First Amendment to the Draft Environmental Impact Report

RACE STREET GENERAL PLAN AMENDMENTS AND PLANNED DEVELOPMENT REZONINGS (GP05-06-01, GP05-06-02, PDC06-024, and PDC06-025)

SCH# 2005062160

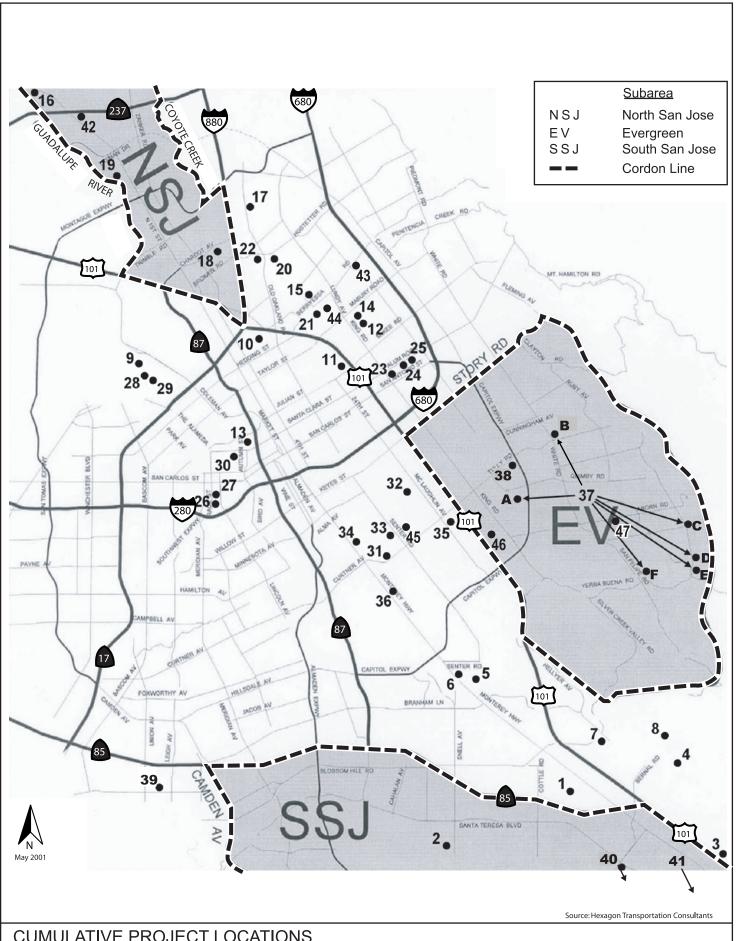
- Page 193 Section 4.2 LIST OF CUMULATIVE PROJECTS; **revise** Figure 18 as shown on page 27 of this document.
- Page 200 Section 4.2 LIST OF CUMULATIVE PROJECTS; **revise** page 200 (Table CUMULATIVE-1) to include additional General Plan Amendments as shown on page 28 of this document.
- Page 204 Section 4.3.1.1 Introduction; **revise** the first sentence of the paragraph:

Page 212 Insert Figure 18a Cumulative Regional Screenlines, as shown on page 30.

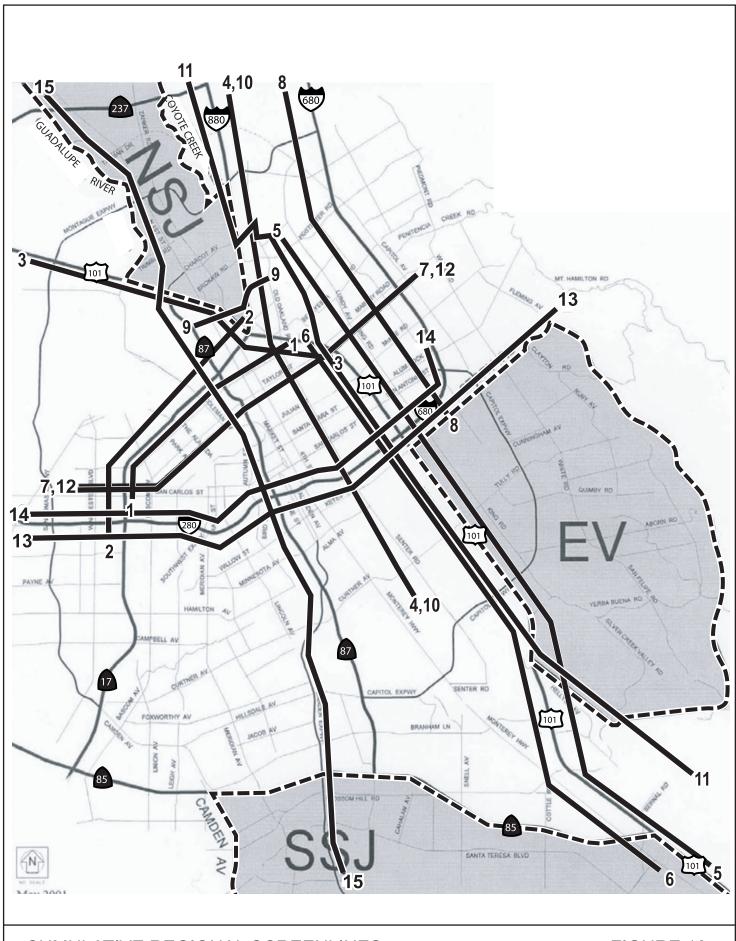
The comment refers to the list of screenlines presented on page 210 of the DEIR that were analyzed to identify the cumulative impacts of the project. The requested graphic showing the location of the screenlines was available in Appendix A. Following receipt of this letter the City's website was accessed to ensure that all appendices of the Draft were available for download and the identified appendix was available at that time. A graphic showing the location of the 15 screenlines is included in *Section 4 Revisions to the Text of the DEIR* in this document in order to clarify the discussion.

CONCEPTUAL
STORMWATER CONTROL
PLAN

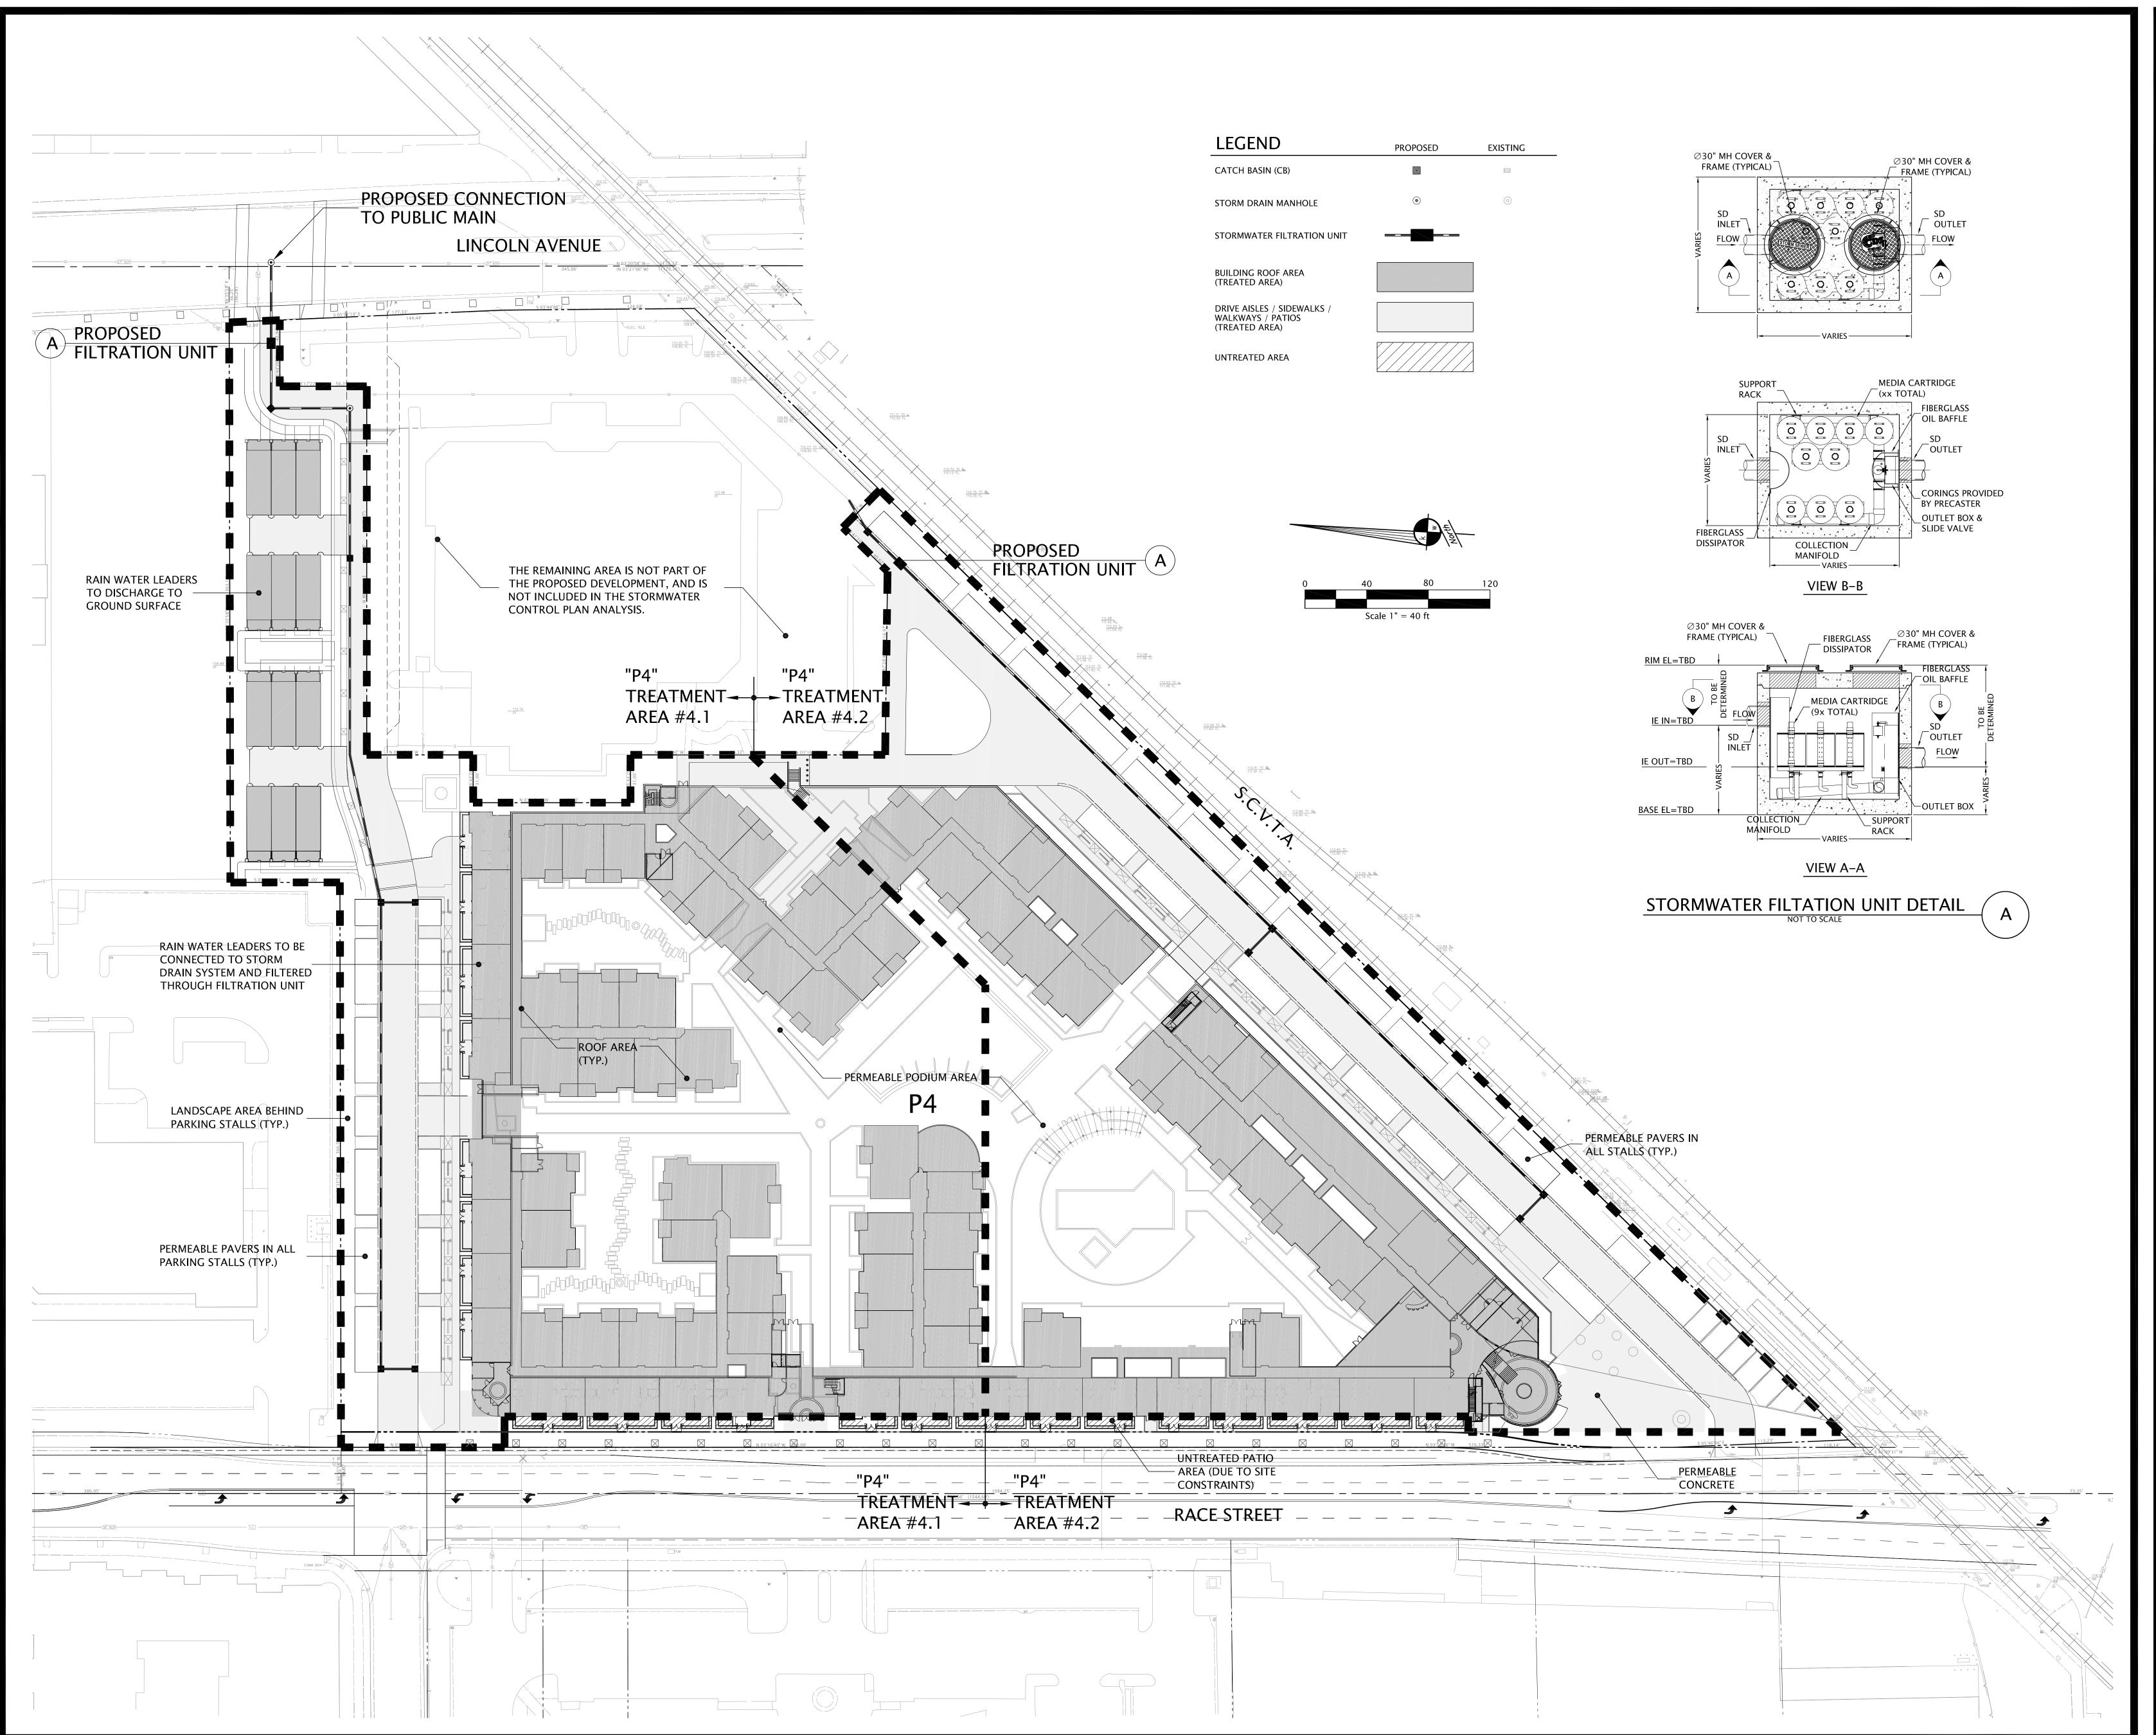
COMMENT E-2: Mitigation Measure Hydro-1.3 refers to numeric sizing calculations for the treatment units. These calculations will be required by the City of San José before a Planned Development Permit is issued for the project. Please provide Water Board staff with these calculations so that we can better understand the design and functioning of proposed treatment units.

The numeric sizing calculations for the currently proposed treatment units has been added to Appendix D as shown in *Section 4 Revisions to the Text of the Draft EIR* of this document.
